# Mesa Public Library Noise Issues

# Level 2 Meeting Rooms

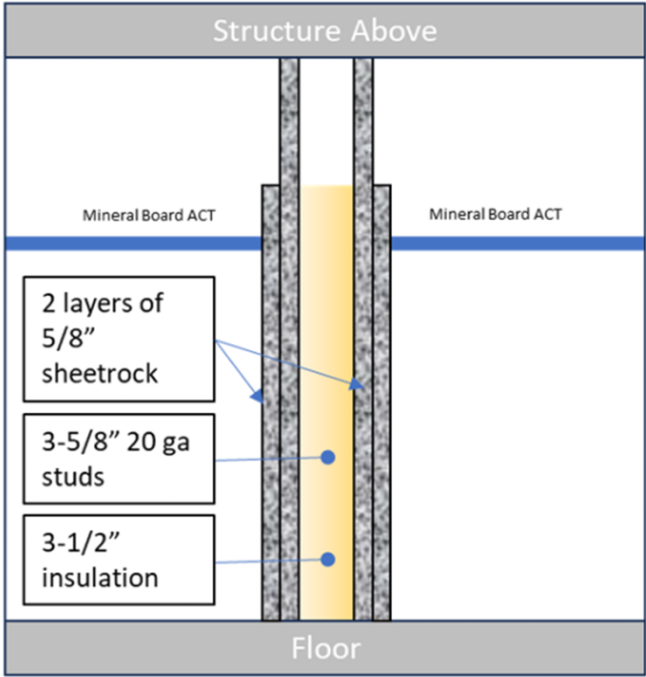
- Sound transmission between adjacent rooms when the operable partition are in use is poor.
- Speech intelligibility between meeting rooms relates to both the audibility of the intruding sound and the intelligibility of the speech itself.
- Eliminating the sound transfer entirely is not feasible with an operable wall.
- Over time the seals on the operable walls can become misaligned or degrade and no longer seal.

- It is recommended that the library contacts its local folding partition vendor (Modernfold is installed) to perform a maintenance inspection and to verify the integrity of the seals and wall panels.

- If this evaluation does not yield any noticeable improvements the we recommend that the replacement of the existing partitions be considered.
- If replacement is the path forward, a newer option providing a higher level of sound isolation can be selected.

- We recommend that a partition with an STC-53 or better be selected.
  - This can be the Moderco Signature 800 or the Modernfold Encore
  - It should be noted that although operable partitions can be rated above an STC-50 they often perform 5-7 point lower than their STC rating once installed, due to various in-field conditions.

- The alternative is to replace the folding partitions with a fixed wall assembly. Although this would eliminate the flexibility of the space, the STC-55 assembly will achieve a superior level of acoustic noise reduction as compared to an operable wall.

## Level 1 – Group SC Room & Small Study/Phone Rooms

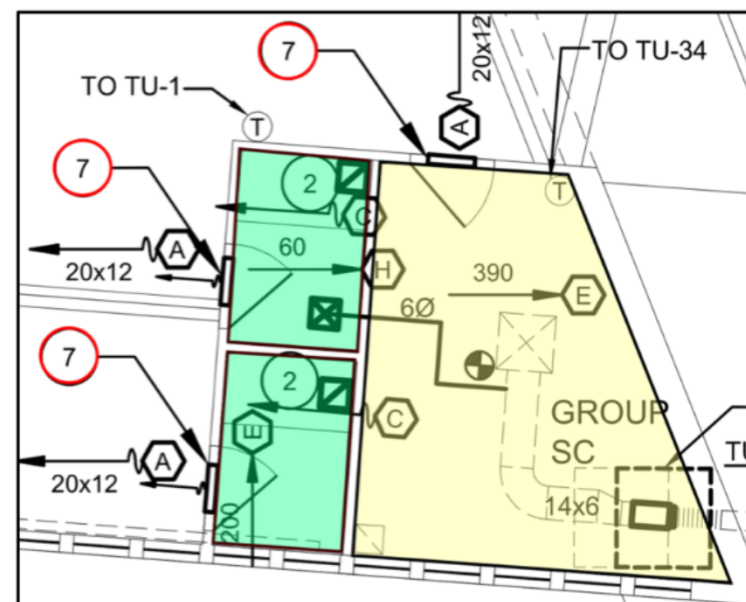
- **Group SC Room:** Elevated temperatures have occurred in this room prompting an increase in airflow to improve cooling. However, the added air volume is resulting in higher background noise levels in the room.

- **Inter-room Noise Transfer:** Sound is transferring between adjacent rooms. This occurs through 2 primary paths.
  1. Directly through the wall structure, which is dependent upon the performance of the assembly. (STC rating)

2. Indirectly through the ceilings, where sound travel through the ceiling, over the top of the wall, and then enters the adjacent space through the ceiling of the neighboring room. (CAC rating)

- **Noise Leakage to Public Areas:** Sound from the enclosed rooms is also escaping into adjacent public spaces via the return air openings located in the walls. These openings are shown as red circled “7” in the layout. The return air openings are located within the walls or doors below the room’s ceiling plane.

# Level 1 – Lisa Rivera's Offices

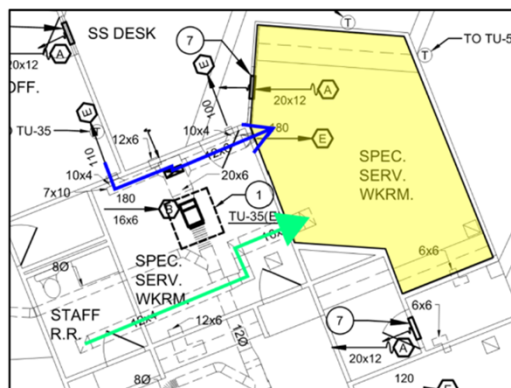
- This office features an open ceiling design with exposed wood framing.
- **Loading dock door noise:** A squeaking sound is consistently heard from the operation of the loading dock door located directly beneath the office.

- It is suggested that WD-40 or similar be applied to the loading dock door hinges.
- **Intermittent Loud Disturbances:** On occasion, loud noises resembling someone screaming have been heard. Most likely this is occurring through the duct path that is connected to adjacent rooms, such as Staff Restrooms or the OC Office.

- It is suggested that a 5-foot section of duct connecting the office to the restroom and the OC Office be internally lined with fiberglass ductliner. Alternatively, this section of duct can be replaced with 5-foot-long insulated flex duct.

- **Airborne Sound Transmission:** Noise is also transferring into and out of the office through the wall mounted return air opening.

## Option 1: Relocate Return Air Path to Occur Over the Ceiling

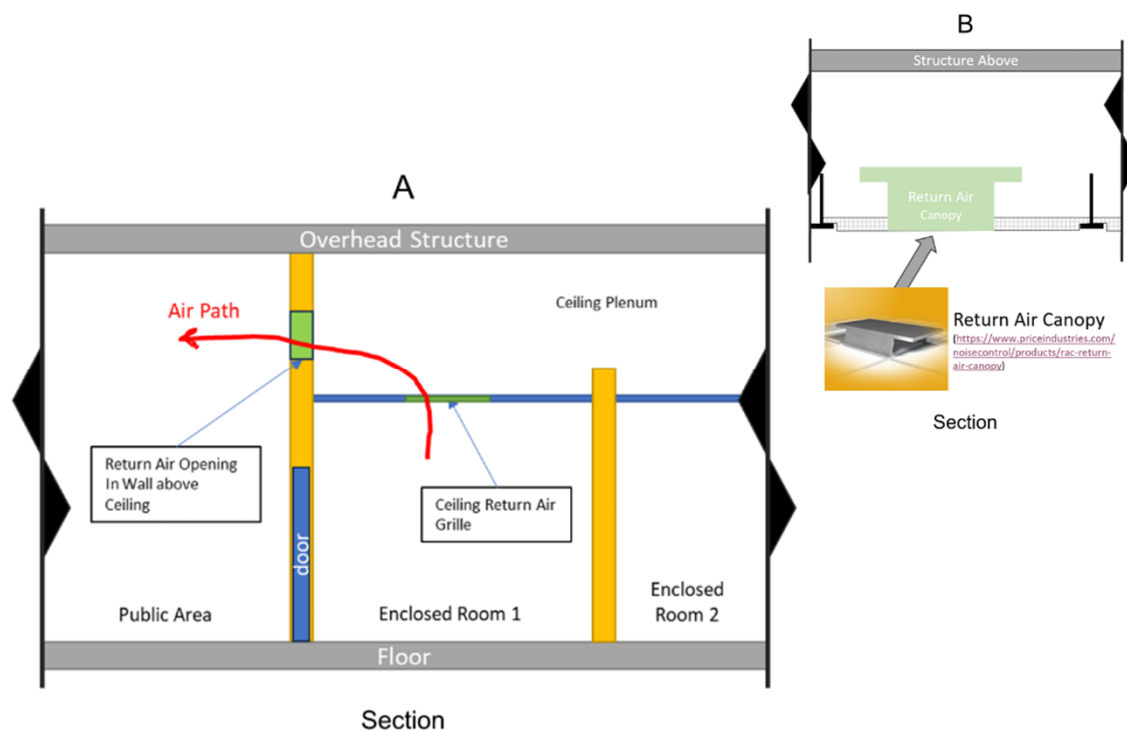
- Close the existing opening in the wall opening with sheetrock. If the opening is in the door, then close it off with plywood or replace the door.
- Add a return air grille to in the ceiling plane within the room to allow for return air to enter the plenum space above the ceiling.
- Install a return air canopy above the new return air grille in the ceiling.
  - [Price Return Air Canopy](https://www.priceindustries.com/noisecontrol/products/rac-return-air-canopy)
- Add an opening in the wall above the ceiling plane to allow for the air to pass from the room out into the public space.

This new return air path is shown in red in the illustration to the right.

### Option 2: Noise Control of Existing Return Air Openings

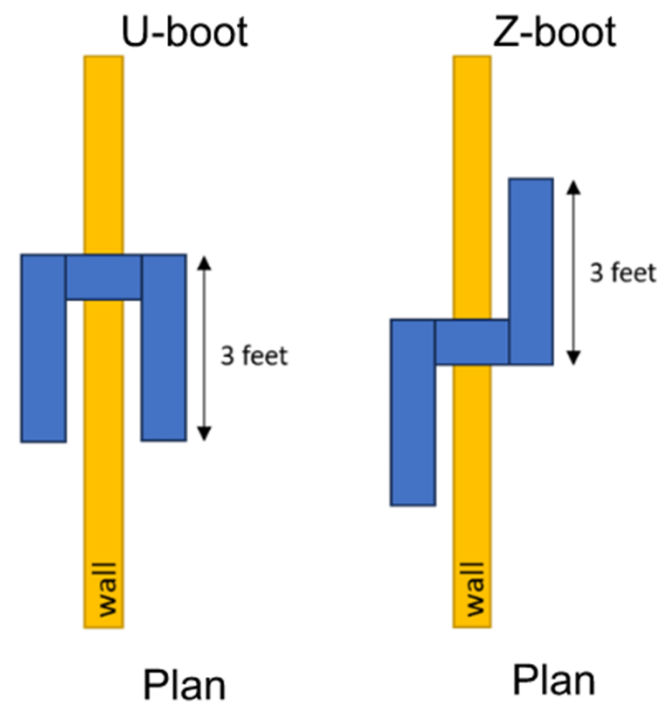
- Reposition the wall opening as close to the ceiling as feasible and install an acoustic U or Z-shaped lined transfer boot, as shown.
- If the return air opening is within the door, seal it off and create a new opening as close to the top of the wall as possible using the transfer boot.
- This transfer boot should be constructed using sheet metal ductwork, that is internally lined with 1" thick black-matted fiberglass duct liner to achieve effective sound attenuation. Each leg of the boot should extend roughly 3-feet, while the length of the section passing through the wall can match the wall's thickness.
- To preserve sound isolation, all wall penetrations must be sealed airtight with a resilient acoustical sealant, equivalent to the [USG Acoustical Sealant](#).

# Level 1 Mitigation Options – Noise Transmission Between Rooms

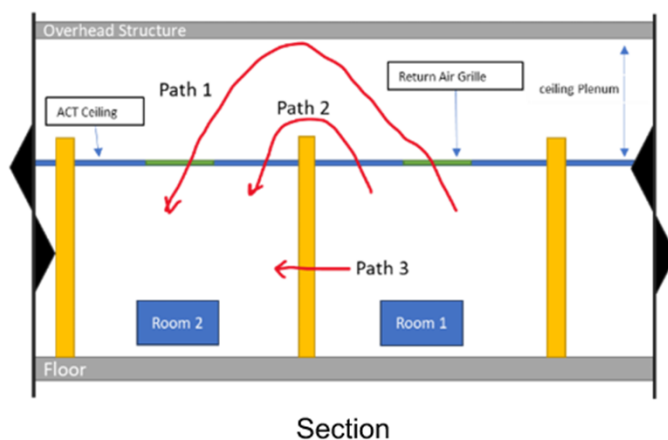
- Existing walls in most rooms were determined to be constructed using 1 layer of sheetrock on each side of 3-5/8" metal studs with no insulation in the stud cavity. This wall performs around an STC-35 to STC-40.
- Walls are partial height and stop above the ceiling.
- The ceilings appear to be a mineral board ceiling tile which performs around a CAC-30 to CAC-35.
- With the open return grilles in the ceiling located close to one another, the performance through the ceiling is expected to be reduced. Therefore, the combined architectural separation between rooms is expected to be around an STC-35.

## Paths of Noise

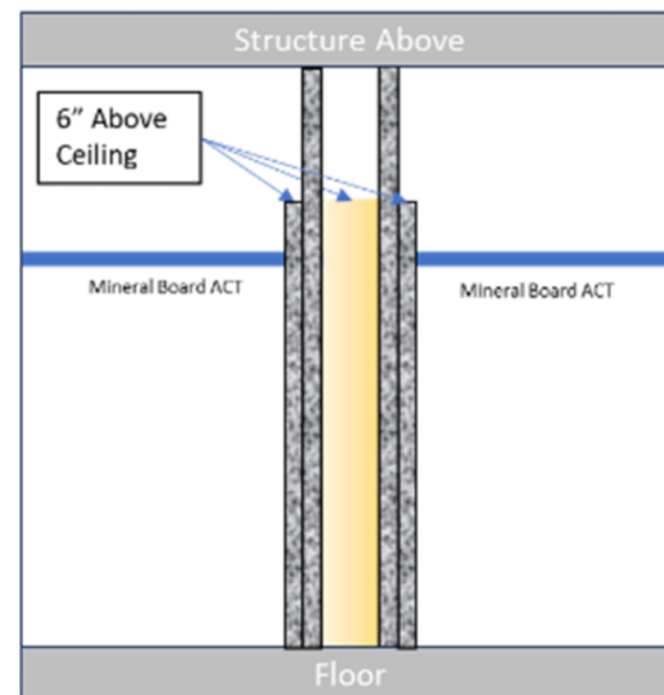
- **Path1:** Through the return air opening into the ceiling plenum and back down through the return air opening into Room 2
- **Path2:** through the ACT tile into the ceiling plenum and back down through the ACT tile into Room 2
- **Path3:** through the body of the wall

### Option 2: Improve Demising Walls & Block Open Plenum Above Ceiling

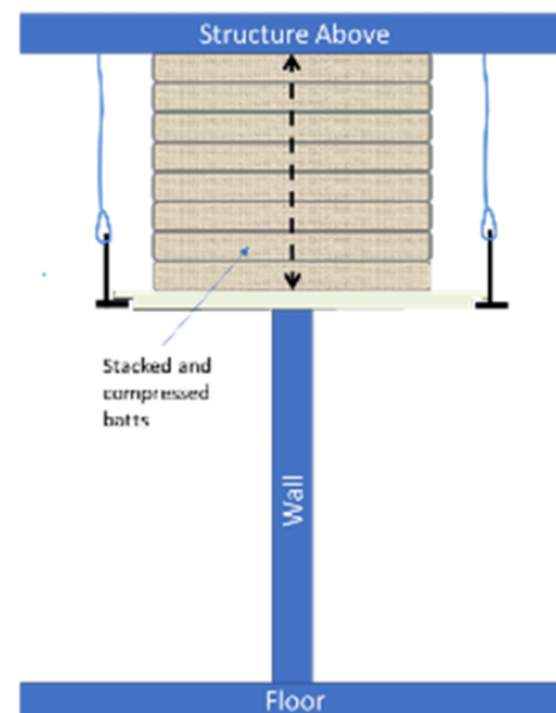
- Add insulation to the existing wall cavity. This can be done by removing the sheetrock on one side of the wall to add fiberglass or rockwool batt between the studs, or by keeping the sheetrock in place and blowing in loose insulation.
- Add 1 layer of 5/8" GWB on each side of the existing wall, for a total of 2 layers per side.
- Stack 16" wide fiberglass or mineral wool batts very tight from the ceiling plane to the underside of the concrete structure continuously for the entire length of the wall. The batts should be centered at the wall. Compress each layer down so that the whole stack is compressed.
- This option replaces the extension of GWB to structure as shown.

### Option 3: Improve Demising Walls & Improve Ceiling Path

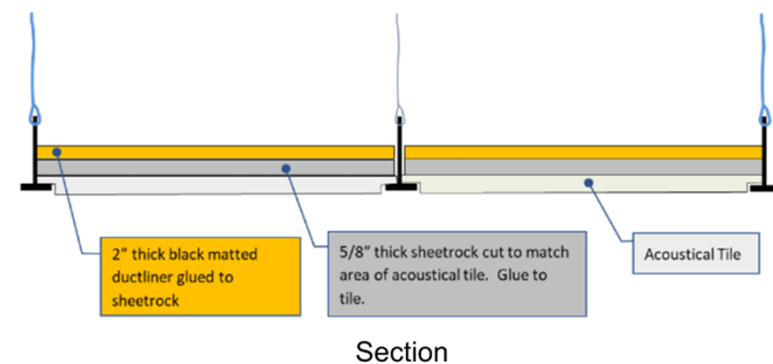
- Add insulation to the existing wall cavity. This can be done by removing the sheetrock on one side of the wall to add fiberglass or rockwool batt between the studs, or by keeping the sheetrock in place and blowing in loose insulation.
- Add 1 layer of 5/8" GWB on each side of the existing wall, for a total of 2 layers per side.
- Install the Return Air Canopy on top of the ceiling return grilles in each room separated by the wall being improved.
- Cut 1 layer of 5/8" GWB to match the area of the acoustic tile and glue it to the back of the tile.
- Cut 2" thick black matted fiberglass ductliner to match the area of the acoustic tile and glue it to the top of the glued-on sheetrock.
- Utilize this upgraded ceiling tile throughout each room to address noise transmission issues.

## Level 1 – Operations Librarian Office

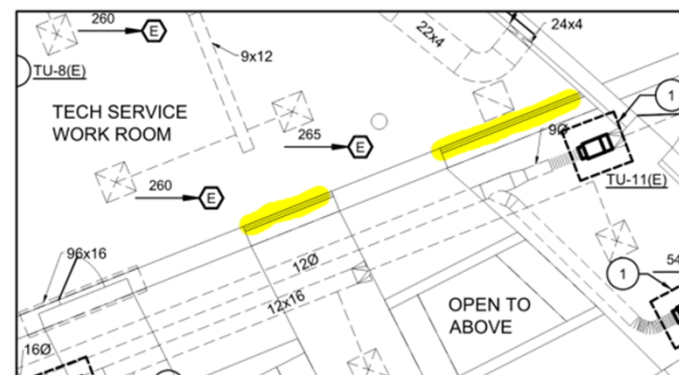
- Although this Level 1 office is currently vacant, the reported noise issues involves conversation within the space being audible in the adjacent public areas.
- Sound is easily passing through the single-pane wall mounted window.
- This window is now permanently sealed.
- Staff in the workroom can hear kids from the Children Collection Area through the single pane windows, highlighted in yellow.

- If the window is no longer needed, remove it and fill in the opening to match the wall's constructed assembly.
- If the window is still needed, replace it with a double pane window consisting of 1/4" glass\_1/2" airspace\_1/4" glass
  - This glazing assembly is expected to improve sound isolation by approximately 10 dB compared to the existing glass, effectively reducing the noise transmission by half.

## Ground Level – Young Adult Reading Area

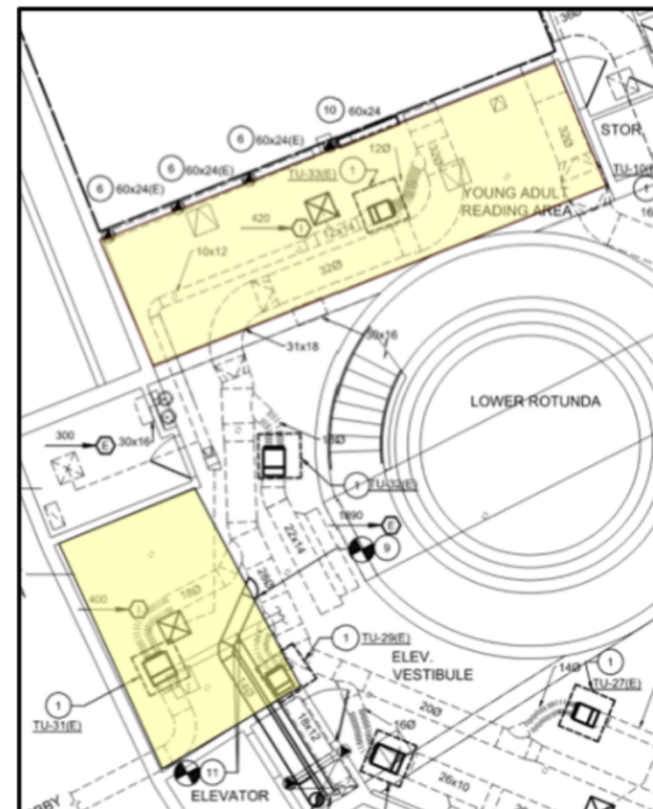
- Elevated background noise levels are present within the areas shown in yellow.
- This appears to be due to excessive airflow. When standing in these locations, one can feel a strong air current and observe nearby decoctions visibly moving, indicating high velocity air movement in the space.

- The background noise levels was measured to be 59 dBA (NC-52) which is substantially above the recommended background noise level of library reading zones of 35 dBA (NC-30).

- The Test & Balance Report dated February 25, 2019 was reviewed as part of this investigation and was assumed to be the final version.
- However, upon examination, several items listed on pages 8-10 remain unresolved. These include:

- Terminal units TU-33 and TU-31, located above the Reading Area per plans, are reported as balanced to maximum airflow rates of 1120 cfm and 2195 cfm respectively.

- But based on the pronounced airflow and movement of hanging elements in this area, it is likely that the actual airflow and associated airflow velocities in these zones are exceeding the reported values.

- It is also conceivable that the air reaching the Group SC Room on Level 1 is impacted by the amount of air being lost over the Youn Adult Reading Area, resulting in less air available to cool this room and possibly other rooms in the library.

## Ground Level – Young Adult Reading Area

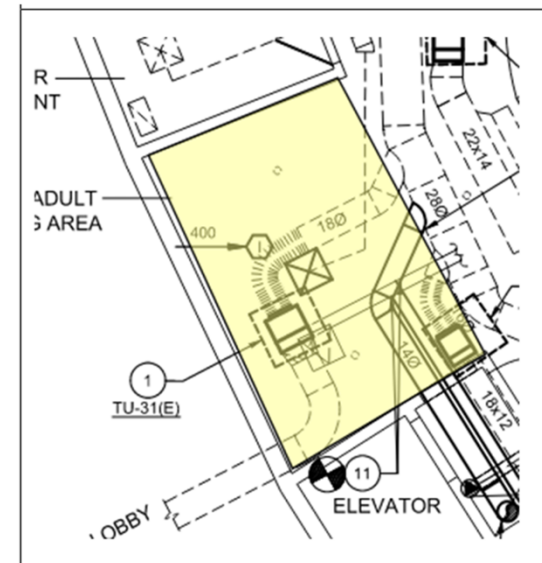
- Check the air balance of the HVAC System.
  - It is quite possible that if the system is out of balance, then correcting the airflow balance may just resolve the noise issues on the ground level and the airflow issues in other parts of the library.

- This would need to be completed by a mechanical contractor or balancing/controls engineer.
- If system balancing is completed and noise issues persist, or if balancing provides unfeasible, and the issues remain, then the following measures should be implemented:

- Replace the open ceiling in the reading area west of the rotunda with a sheetrock ceiling (yellow) which consists of 1 layer of 5/8" GWB with R-11 batts placed on top of the ceiling.

- The second reading area north of the rotunda has an acoustically transparent ceiling and large return air openings located above the ceiling which are connected to the mechanical room wall. Here the Terminal Unit TU-33 should be relocated to the position indicated by the red dot. From there, it should be ducted either above or below the existing 32" round duct. The yellow area below the red dot should be replaced with a sheetrock ceiling. A minimum of 5-feet of lintnerlaly lined ductwork should be instaeed between the terminal unit and the first diffuser using 1" thick fiberglass ductliner to support acoustic attenuation.

## Ground Level – Tech Service Work Room

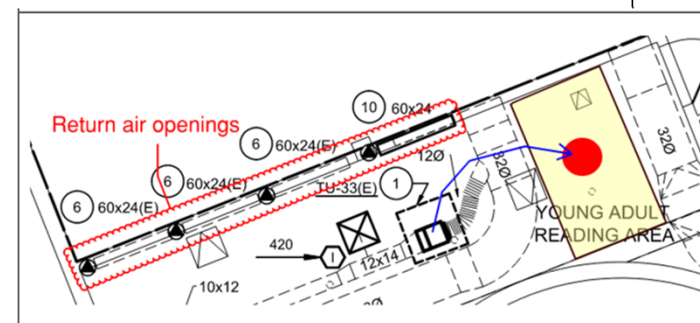
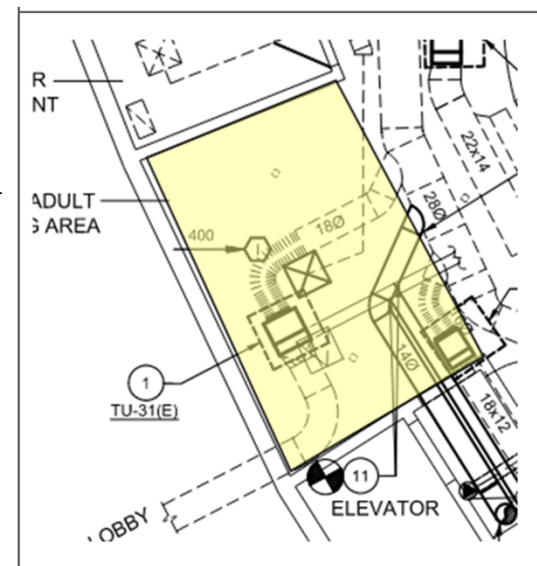
- Check the air balance of the HVAC System.
  - It is quite possible that if the system is out of balance, then correcting the airflow balance may just resolve the noise issues on the ground level and the airflow issues in other parts of the library.

- This would need to be completed by a mechanical contractor or balancing/controls engineer.
- If system balancing is completed and noise issues persist, or if balancing provides unfeasible, and the issues remain, then the following measures should be implemented:

- Replace the open ceiling in the reading area west of the rotunda with a sheetrock ceiling (yellow) which consists of 1 layer of 5/8" GWB with R-11 batts placed on top of the ceiling.

- The second reading area north of the rotunda has an acoustically transparent ceiling and large return air openings located above the ceiling which are connected to the mechanical room wall. Here the Terminal Unit TU-33 should be relocated to the position indicated by the red dot. From there, it should be ducted either above or below the existing 32" round duct. The yellow area below the red dot should be replaced with a sheetrock ceiling. A minimum of 5-feet of internally lined ductwork should be installed between the terminal unit and the first diffuser using 1" thick fiberglass ductliner to support acoustic attenuation.

## Sound Travel through the Rotunda

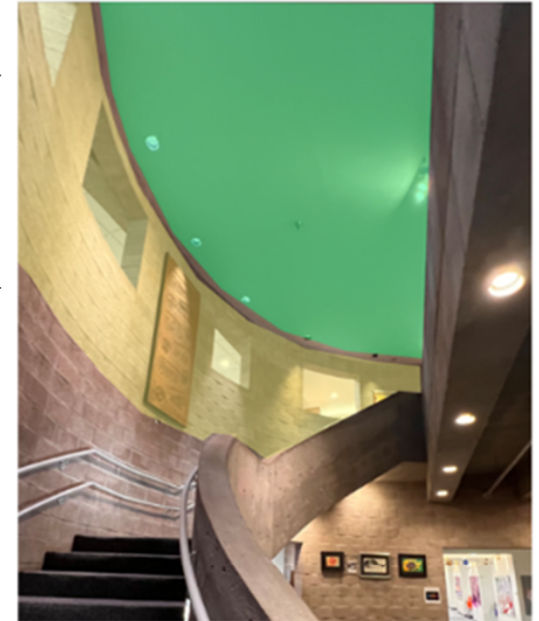
- Children's events are internally scheduled outside of regular business hours to minimize the noise impact on library patrons.
- The event was clearly audible through the rotunda during our visit and into the surrounding areas on all three floors indicating significant vertical and lateral sound transmission

- A noise test was conducted while onsite using a speaker positioned on the ground floor of the rotunda and set to generate white noise. This test was used to evaluate how sound attenuates as it travels vertically through the rotunda.

- Sound levels were measured on the ground floor, Level 1, and Level 2.
- RESULTS:
  - 6 dB reduction in noise between the ground floor and Level 1
  - 25 dB reduction in noise between the ground floor and Level 2

- This is consistent with our observations as the rotunda is more acoustically open between the ground floor and Level 1 as compared to the single door connecting Level 2.

### Level 1 - Bridge

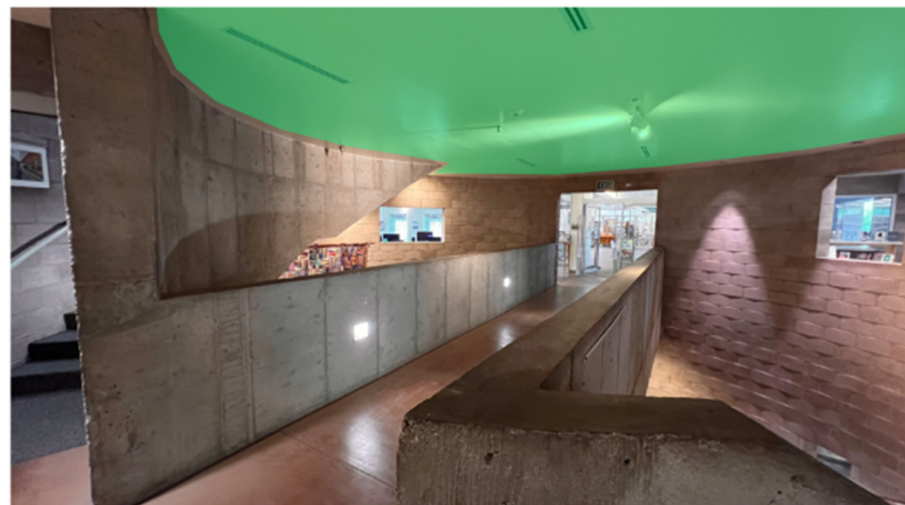
- The purpose of introducing sound absorptive treatments in this area is to limit the transmission of noise originating from the ground level of the rotunda into adjacent parts of the library.
  - Ceiling sound absorption (green area) should be achieved using 1" thick acoustic material with a minimum NRC 0.70.
- Ceiling installations may be interrupted around fixtures such as lighting and sprinkler heads
- Acceptable products include:
  - Felt (Customizable Felt Wall Tiles) or similar
  - Polyester panels
  - Stretched Fabric System (SnapTex, FabriTrak) or similar
  - Fabric Wrapped Panels

### Wall Openings

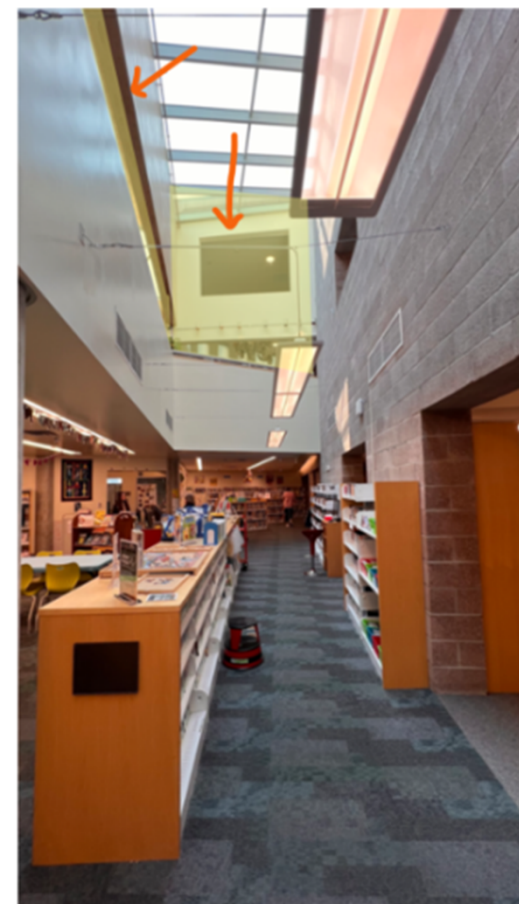
- Multiple openings in the circular walls of the rotunda permit sound to travel into adjacent areas of the library
- Blocking these opening with glass will substantially reduce noise transfer from the rotunda to surrounding spaces.
- The closure of these openings must be carefully coordinated with the building's HVAC airflow dynamics and fire/smoke evaluation requirements to ensure compliance with safety standards and to maintain proper ventilation.
- If closure of the openings is possible, the glass should be 3/8" thick.
